Latest Track Tweaks—Stiffen centre section, Spring pans

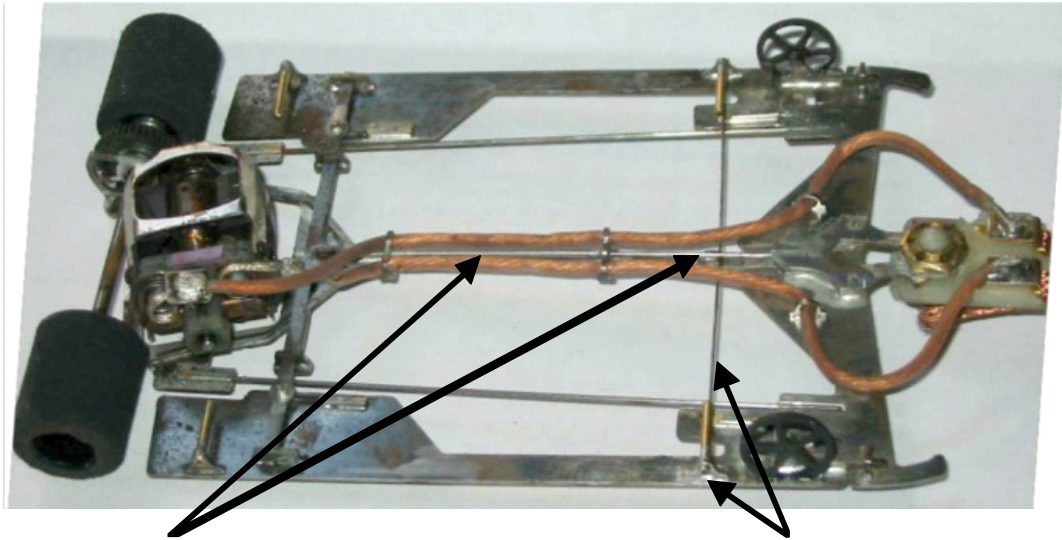
New versions of this chassis now feature a 0.047 centre rail, solder this at the back and also to the two lead wire retainers and the rear of the guide plate. It is also advised to use stainless steel pin tube in the pin mounts.

Cut slots in the underside of both front pin tube mounts so you can slide a piece of 0.015" piano wire under the centre section wire and into the mounts above the pan and below the pin tube. Solder wire to pin tube mounts & tag wire to centre section to "spring pans" lightly in forward position.
